City of Sedona Wastewater Department

The City of Sedona, Arizona is issuing **Addendum # 2** to the plans and specifications as originally issued at the time of solicitation for bids for the **WWRP Tertiary Filter Improvements Project**. For any bid to be considered responsible and responsive, receipt of this addendum must be acknowledged.

CITY OF SEDONA, AZ
TERTIARY FILTER IMPROVEMENTS
 MECHANICAL
FILTER PLAN

CITY OF SEDONA, AZ
TERTIARY FILTER IMPROVEMENTS
MECHANICAL
FILTER
SECTIONS AND DETAILS

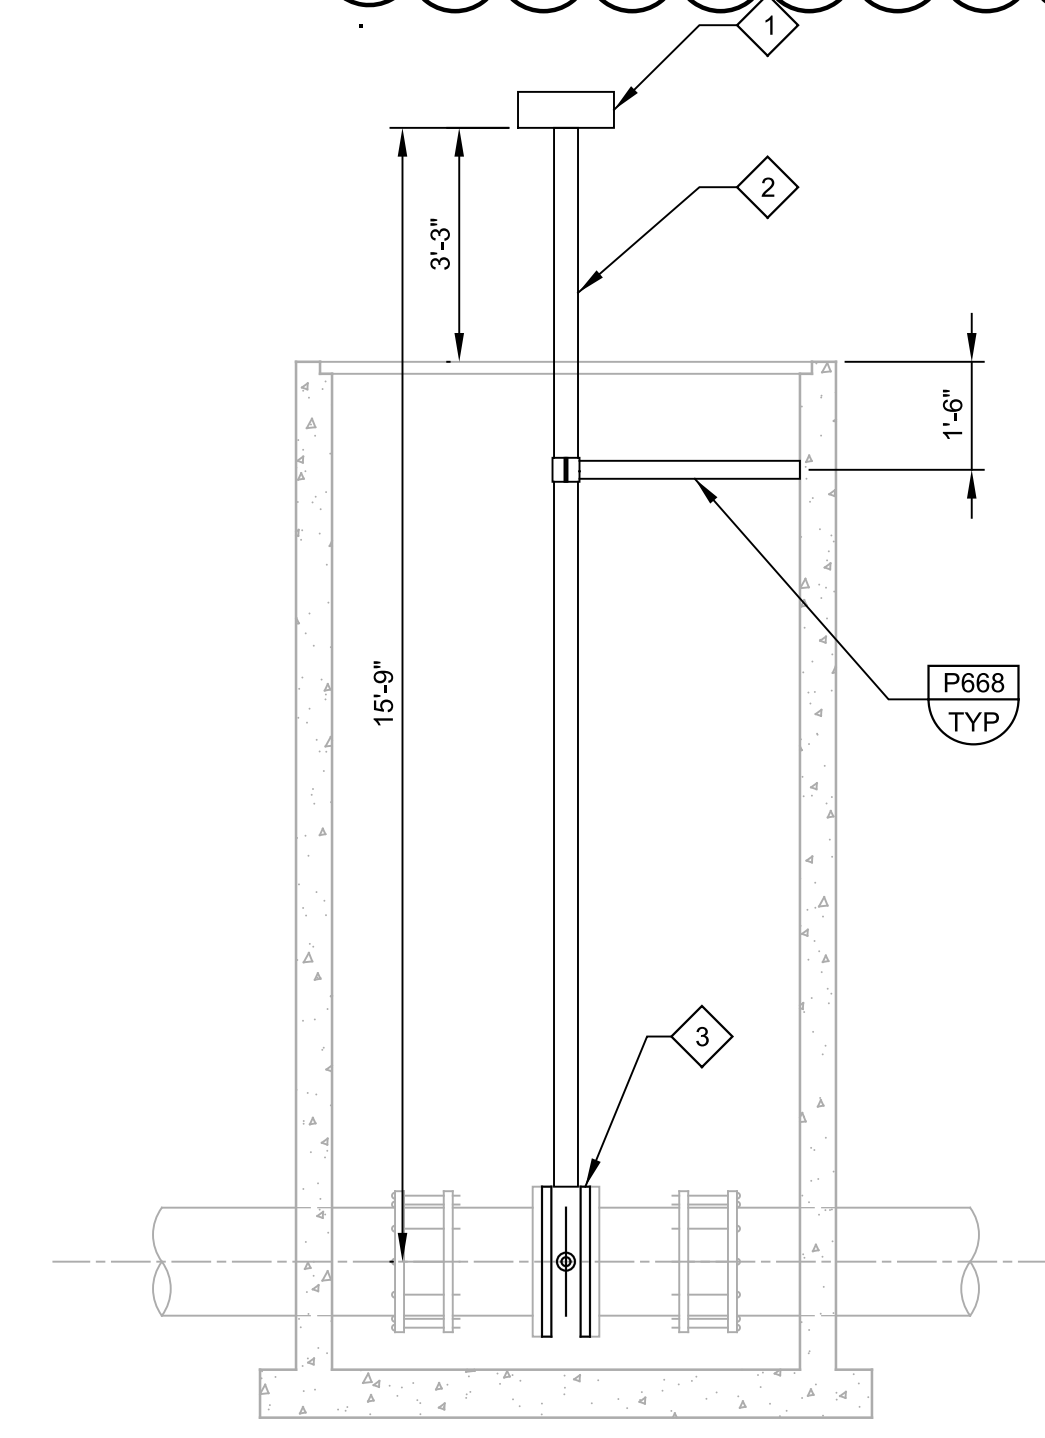
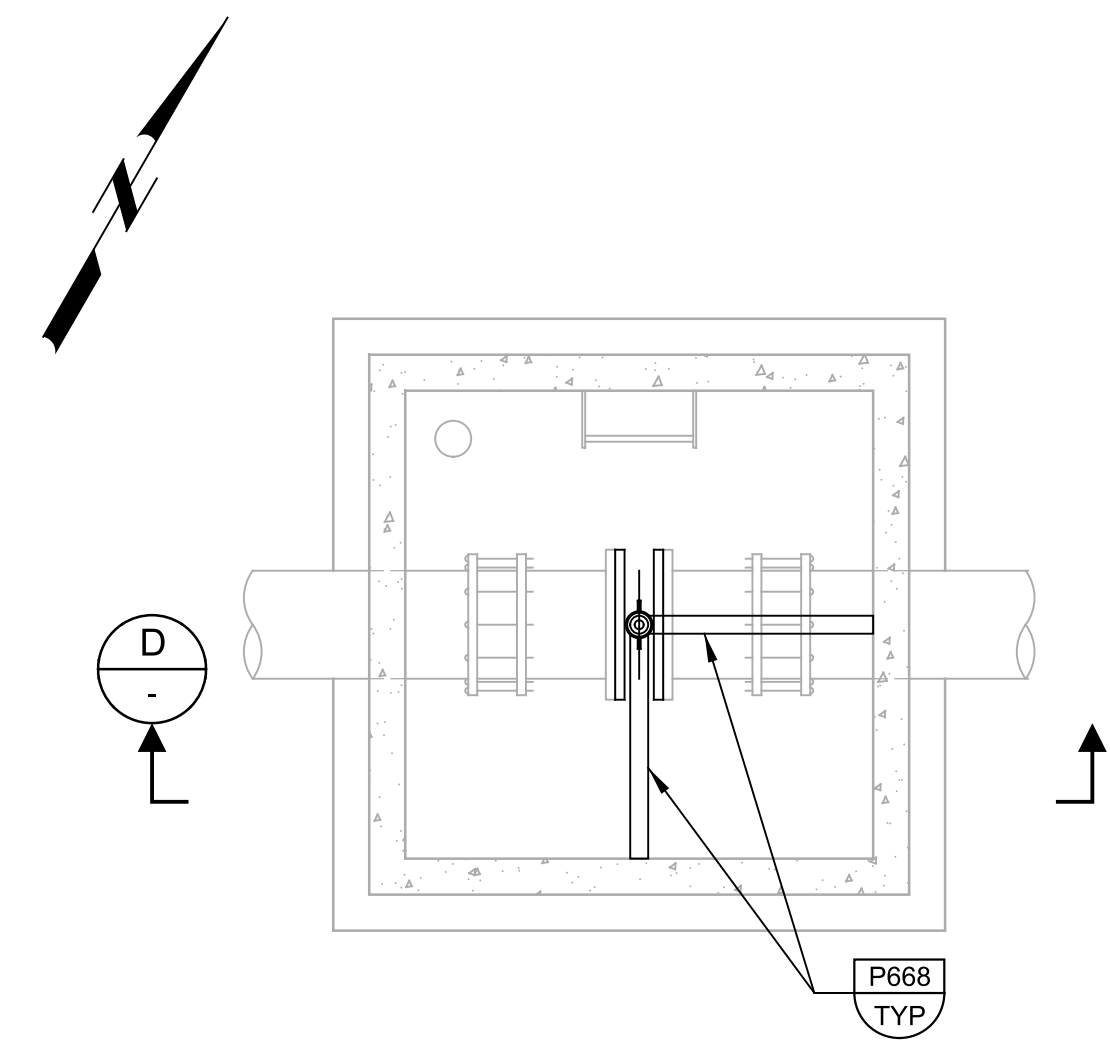
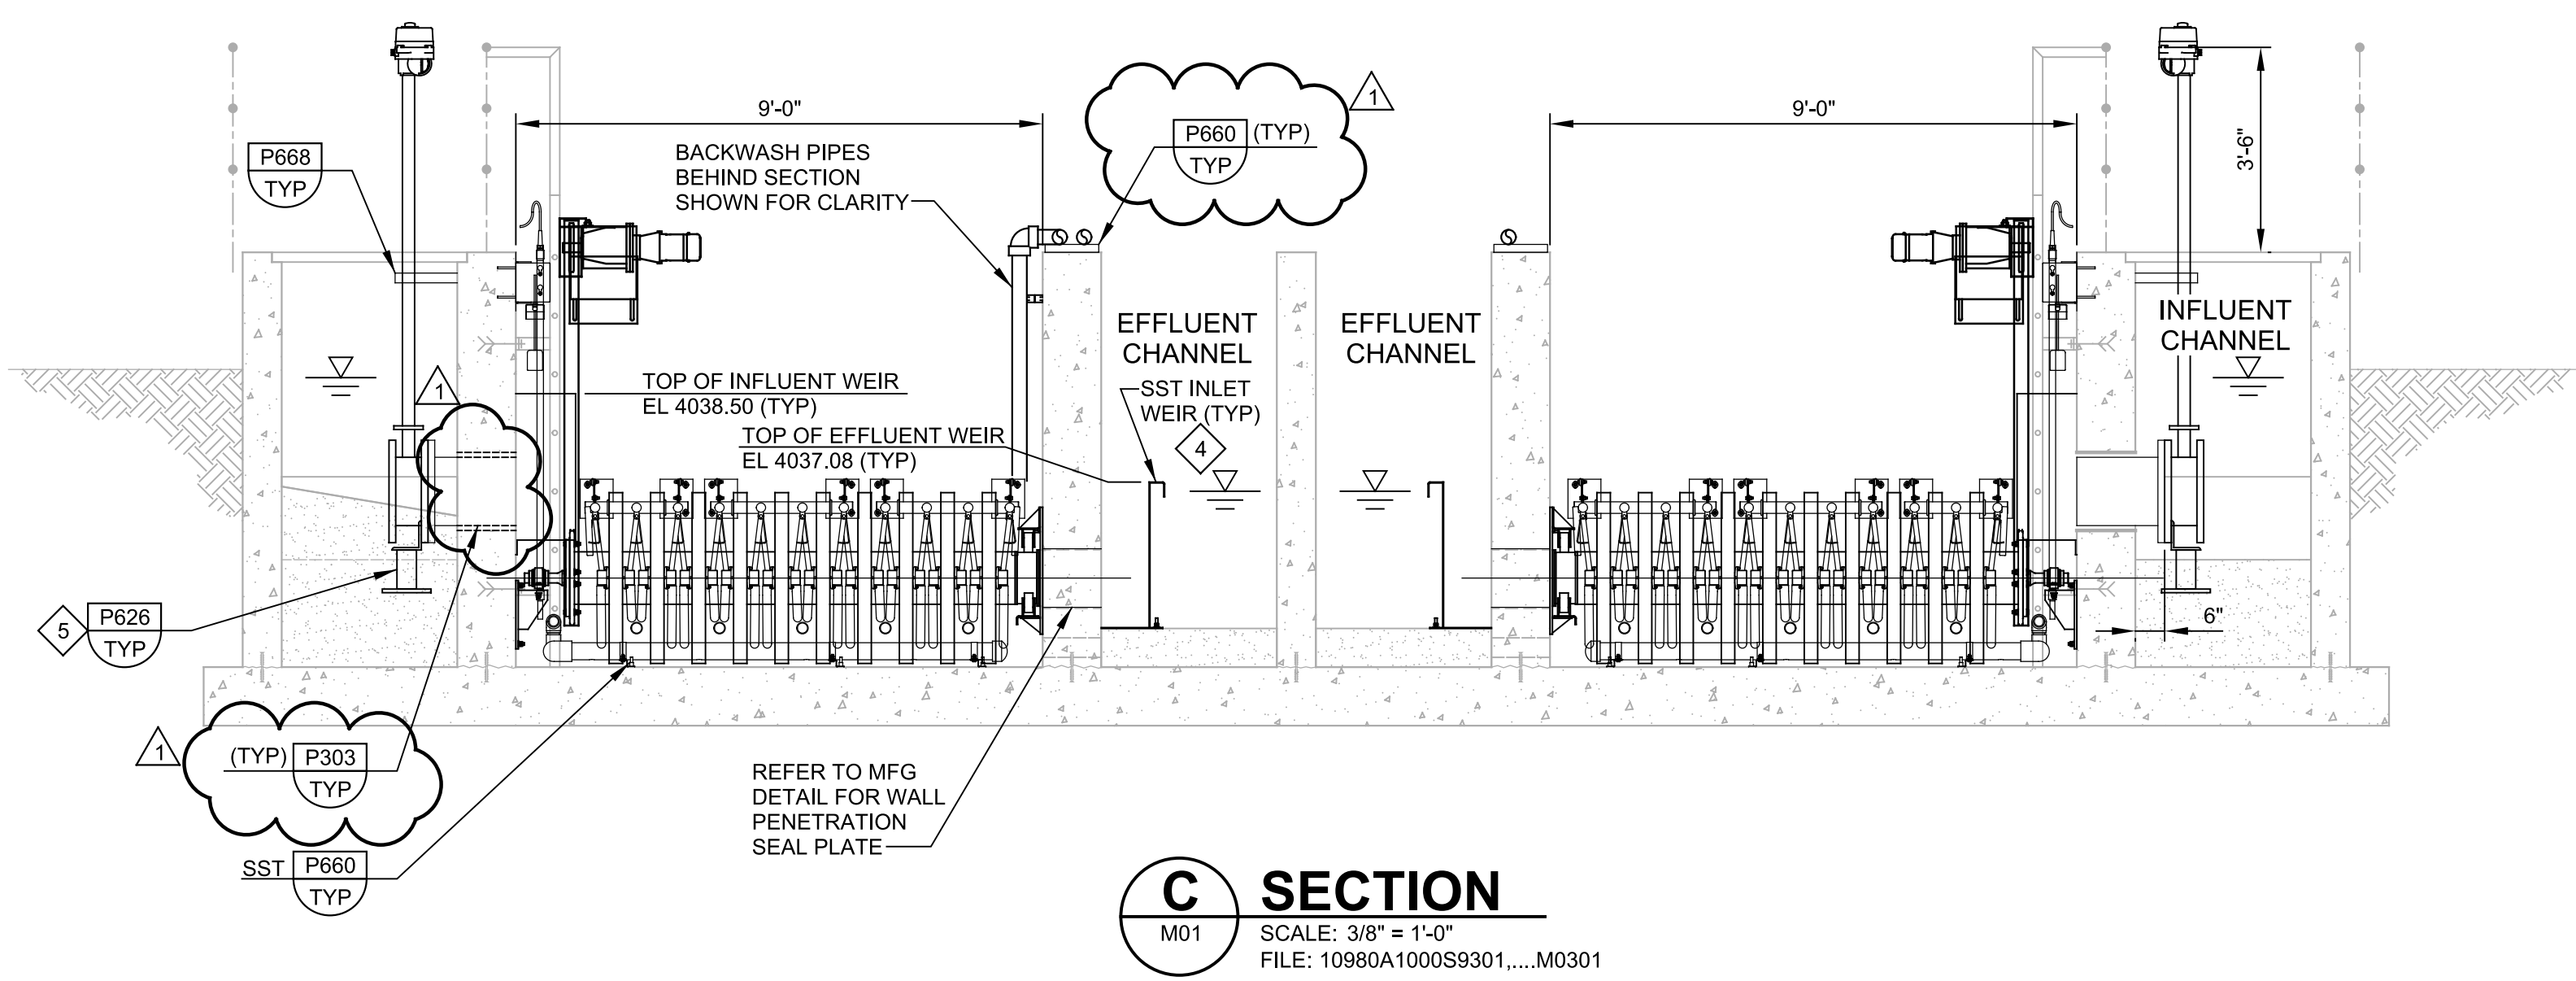
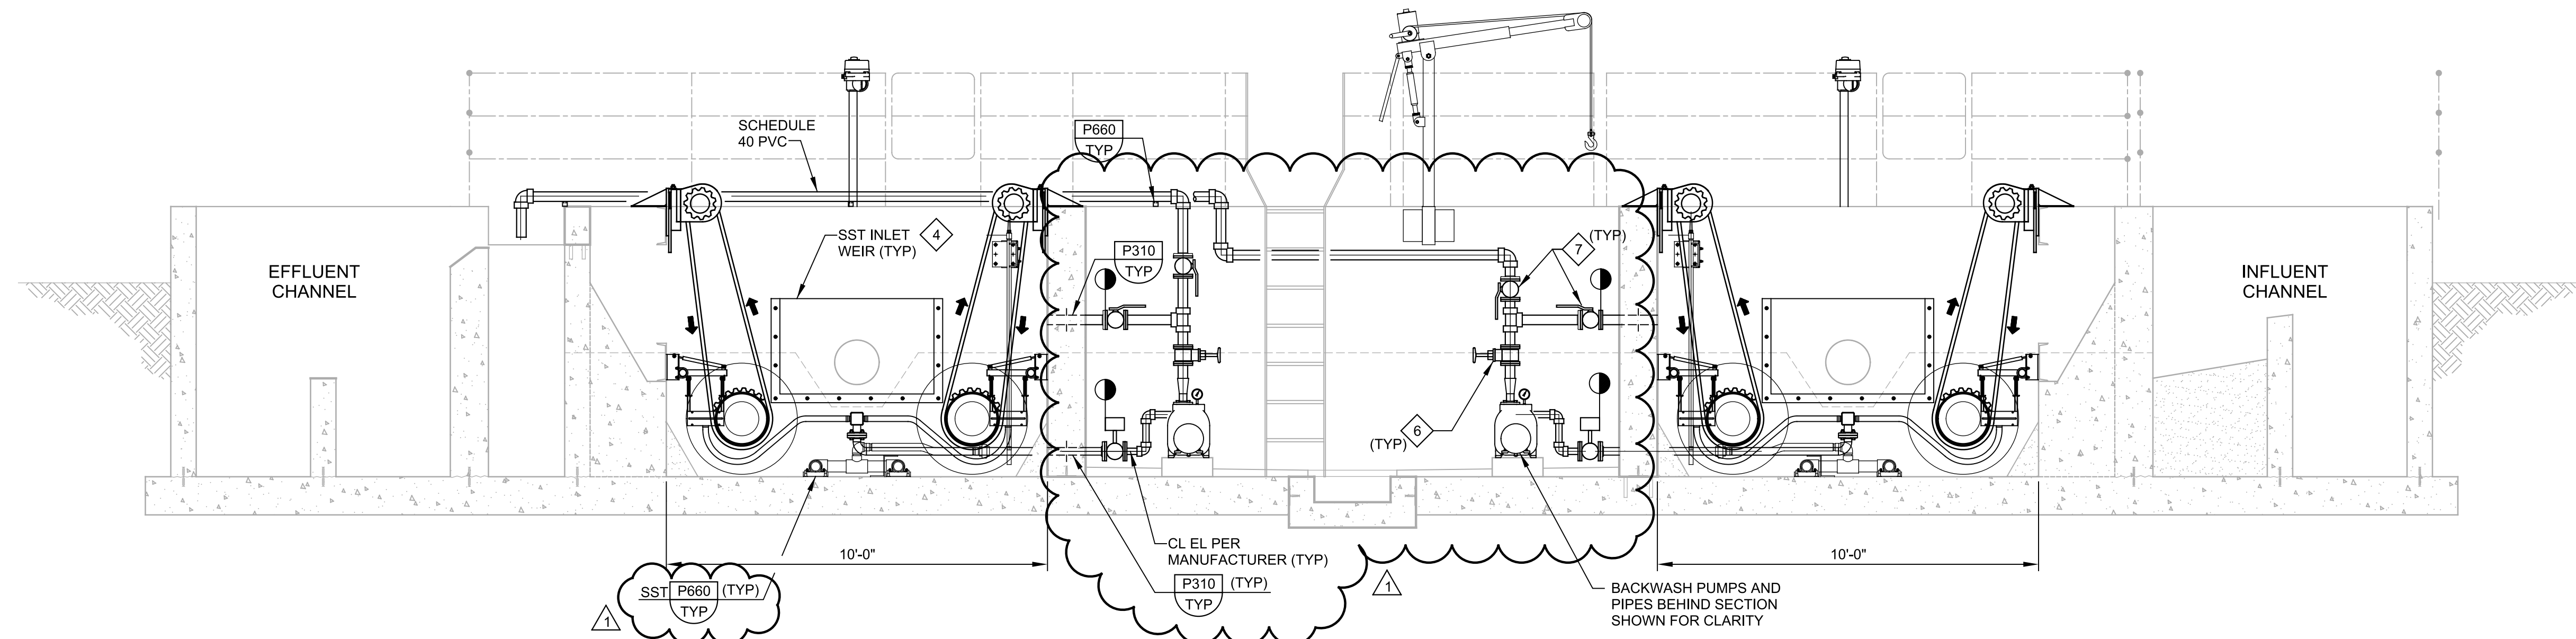
8. **Drawings: REPLACE** drawings M-01 and M-02 with the attached.

Description of changes: Changed the valves on the discharge of the backwash pumps to be shown as flanged instead of threaded, to match the specification. Added "TYP" in several locations to clarify typical requirements. Other minor clarifications.

- KEY NOTES: = #**
- CONTRACTOR TO FURNISH NEW MODULATING SERVICE ELECTRIC ACTUATOR. ACTUATOR SHALL BE 460-VAC, 3-PHASE, AND 60-HERTZ BY MANUFACTURER EMERSON BETTIS, MODEL M2CP SERIES OR PRE-APPROVED EQUAL. CONTRACTOR TO COORDINATE ACTUATOR TORQUE SELECTION WITH BUTTERFLY VALVE SUPPLIER.

- CONTRACTOR TO FURNISH REPLACEMENT 18" AWWA BUTTERFLY VALVE WITH EPOXY COATED BONNET EXTENSION BY DEZURIK OR PRE-APPROVED EQUAL.
 - VALVE REPLACEMENT SHALL BE COMPLETED IN A SINGLE OVERNIGHT FILTER PLANT SHUTDOWN. SEE SECTION 01140 FOR DETAILS.

- CLOTH MEDIA FILTER SUPPLIER TO DESIGN AND SUPPLY SST WEIR BOXES AND WATER TIGHT MOUNTING DETAIL. INSTALLED BY CONTRACTOR.
 - CONTRACTOR TO REMOVE ADDITIONAL EXISTING GROUT UNDER VALVE TO ALLOW USE OF P626

- 3 INCH MANUAL GATE VALVES SUPPLIED BY CLOTH MEDIA FILTER MANUFACTURER PER SPECIFICATION 11366B.
 - 3 INCH MANUAL BALL VALVES SUPPLIED BY CLOTH MEDIA FILTER MANUFACTURER PER SPECIFICATION 11366B.

REV	DATE	BY	DESCRIPTION
1	03-20-19	BDJ	PER ADDENDUM NO. 2
